CITY of NOVI CITY COUNCIL

Agenda Item 2
July 13, 2015

SUBJECT: Approval of the request of GR Meadowbrook, LLC for Huntley Manor, Site Plan JSP 14-56 for a Preliminary Site Plan, Phasing Plan, Wetland Permit, Woodland Permit and Stormwater Management Plan approval in the GE, Gateway East District, with a Special Development Option. The property is located on the south side of Grand River Avenue, west of Meadowbrook Road, consisting of 26.62 acres. The applicant is proposing a 210-unit multiple family, gated community.

SHEET **3**

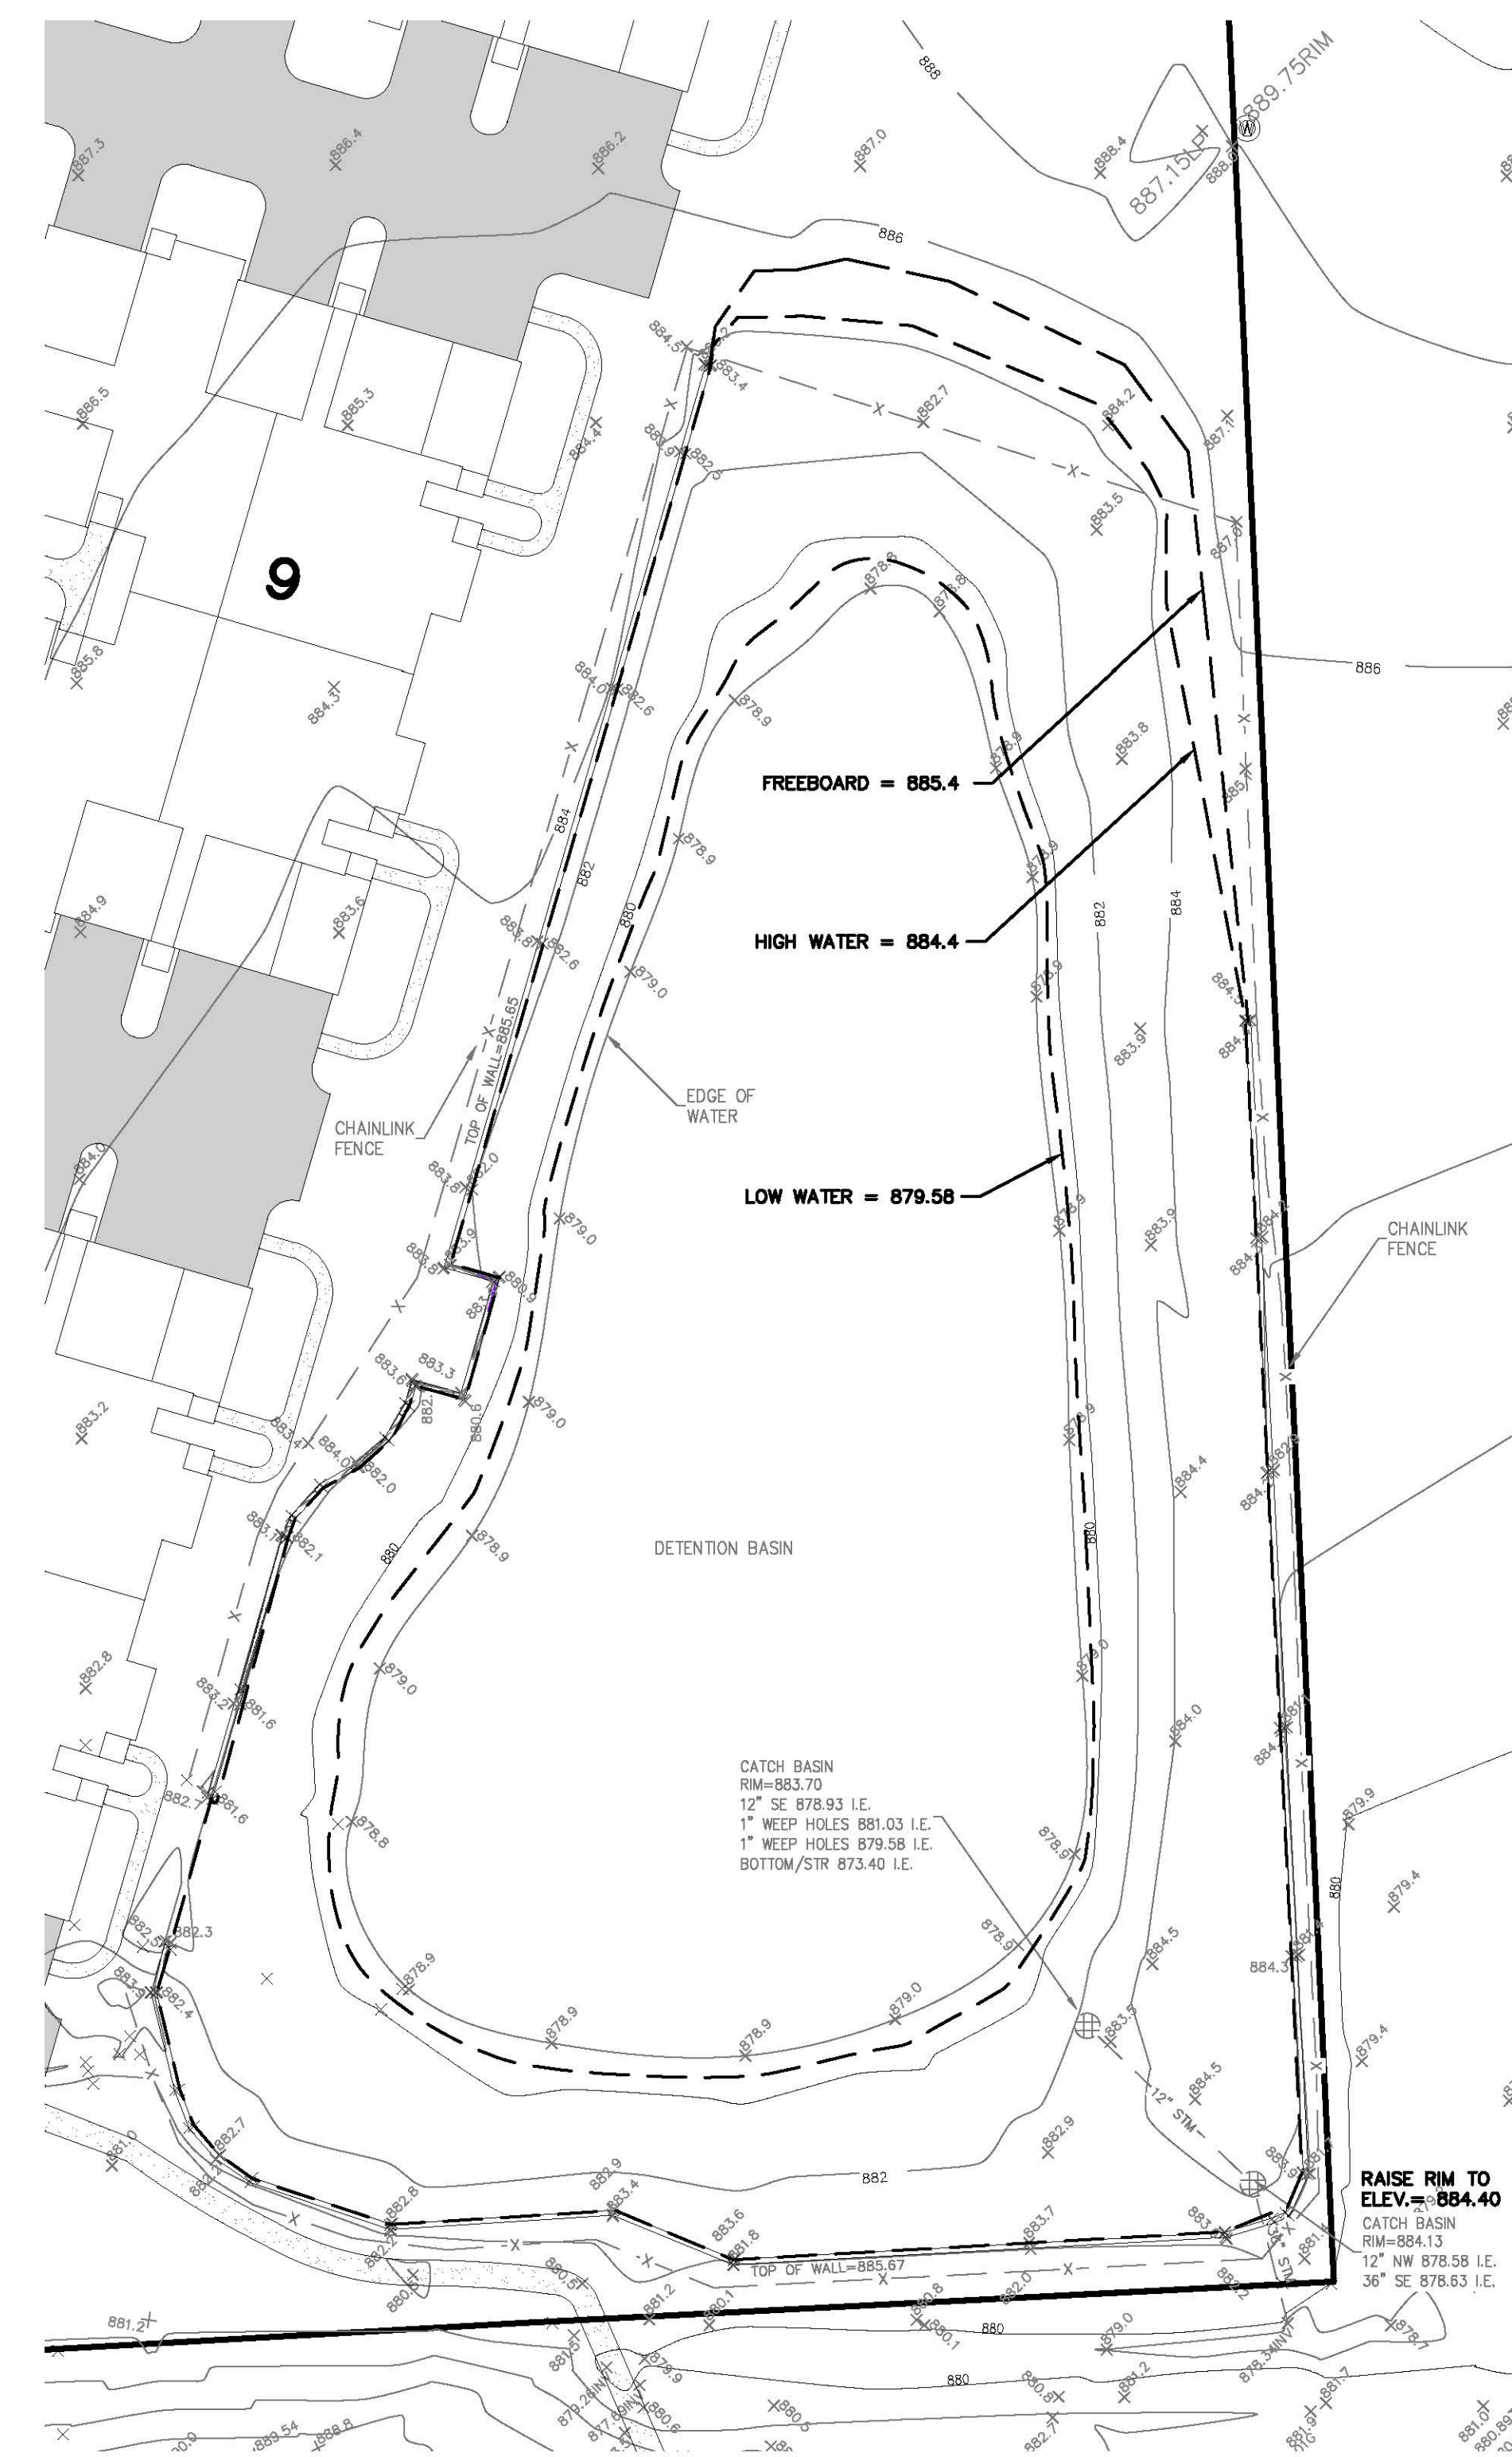
ECT has reviewed the City of Novi Official Woodlands Map and completed an onsite Woodland Evaluation on October 29, 2014. An existing tree list has now been included with the Plan. The *Preliminary Site Plan – South Portion* (Sheet 3) contains a list of existing on-site trees that are proposed for removal. This sheet also indicates the location of the Regulated Woodland Boundary as shown on the City of Novi Regulated Woodland Map (see Figure 1). It appears as if the Plan indicates the location and the diameter of several of the existing trees along the south side of the proposed development/Regulated Woodland Boundary.

The *Preliminary Site Plan – South Portion* (Sheet 3) indicates the proposed removal of seventeen (17) trees. Of these, three (3) of the trees are considered regulated by the City of Novi. The three (3) regulated trees proposed for removal are located along the southern side of the proposed development and include a 9" elm, 10" elm and 14" poplar tree. Although the proposed site development will cover the majority of the site, the majority of the site has been previously cleared for development.

The proposed tree removals appear to require a total of four (4) Woodland Replacement Credits. The *Preliminary Site Plan – South Portion* (Sheet 3) indicates that the Landscape Plans provide additional information (i.e., size, species and location) of the proposed Woodland Replacement trees. After a review of the landscape plans, it is not clear which trees are proposed to satisfy these required Woodland Replacement Credits. The applicant's engineer (Seiber, Keast Engineering, L.L.C.) has stated in a response letter dated December 4, 2014, that four (4) replacement tree locations and tree types will be provided at the time of Preliminary Site Plan submittal. The trees will be planted in the existing conservation easement. The Applicant shall review and revise the landscape plans as necessary.
